RE: Preliminary Design Investigation (PDI) Work Plan – Addendum Marinette Former Manufactured Gas Plant Site, Marinette, Wisconsin Wisconsin Public Service Corporation CERCLA Docket No. V-W-06-C-847; Site Spill ID – B5BT; CERCLIS ID – WIN000509952

This letter serves as Addendum 1 to the Preliminary Design Investigation Work Plan (PDI Work Plan) – Revision 2, dated March 13, 2020, for the WPSC Marinette Former Manufactured Gas Plant (MGP) (the Site).

PRELIMINARY DESIGN INVESTIGATION WORK PLAN ADDENDUM WPSC MARINETTE FORMER MGP SITE MARINETTE, WISCONSIN

FIGURE 01

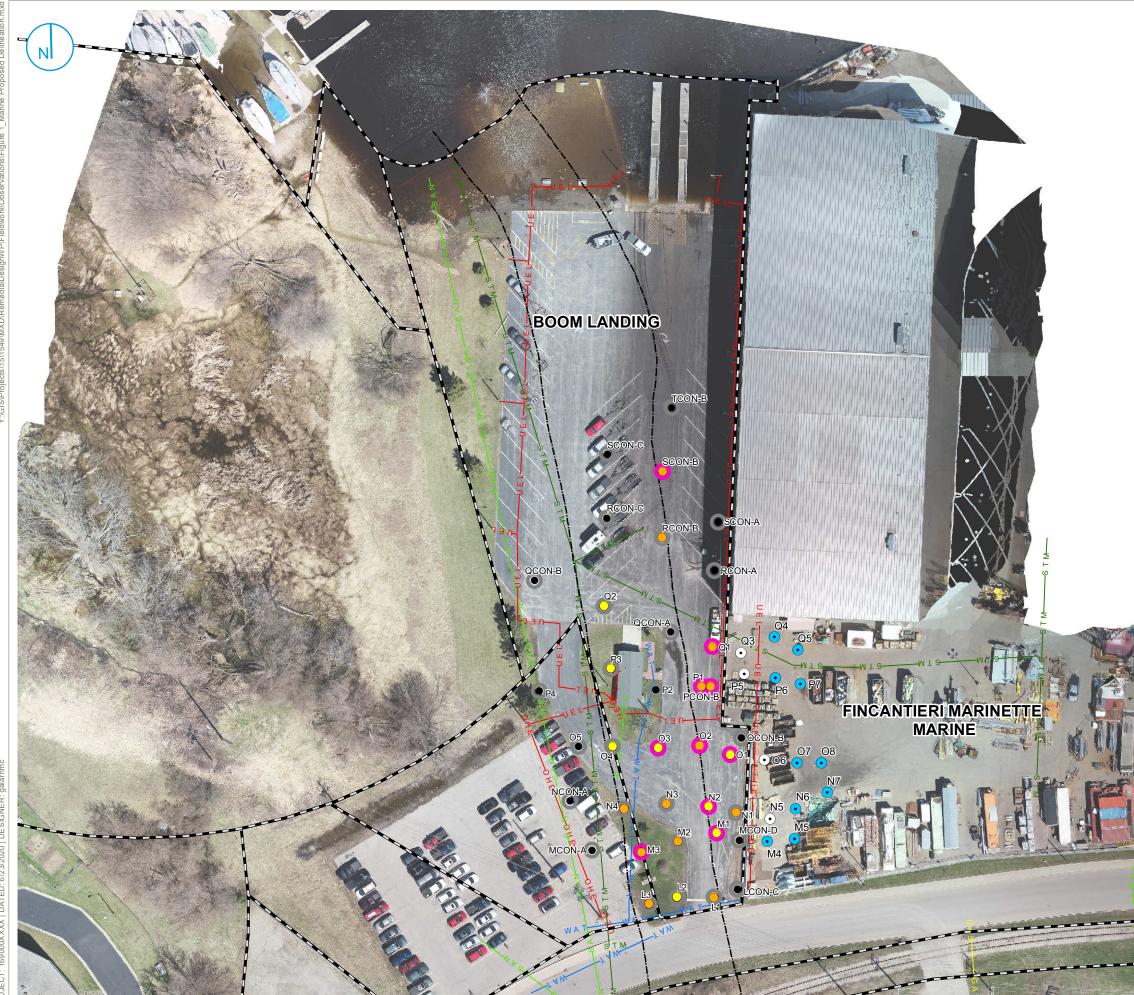
Four additional soil borings are proposed to complete delineation of source material in the equipment storage yard at FMM. The proposed locations of these soil borings are shown on Figure 1 and sampling rational is outlined in Table 1. Soil borings will be completed and sampled consistent with Section 4.3.1 of the PDI Work Plan, Revision 2. Additional contingent step-out borings will be advanced in the event that a definition of extent of source material impacts in this area is not achieved after the installation of the initial delineation borings. The potential locations of contingent delineation step-out borings are also shown on Figure 1; however, these locations may be modified to reflect actual delineation data gaps and possible above- or below-ground physical obstructions present on the FMM property. The precise number and locations of the delineation borings will also be confirmed in the course of WPSC negotiating and executing an access agreement with FMM.

As noted, the work will be conducted in accordance with the procedures outlined in the PDI Work Plan, Revision 2. Prior to advancing the soil borings, a public and private utility locate will be performed. Sonic borings will be advanced at the locations shown on Figure 1. Once the borings are completed, a topographic, boundary, and utility survey will be conducted on this portion of the FMM property including: property boundaries, structures and driveway entrances, easements, above-ground and underground utilities as identified during the utility locate process, existing site features such as fences, fence gates, asphalt/concrete surfaces, the final location of the soil borings, and a site topographic survey with 1-foot contours.
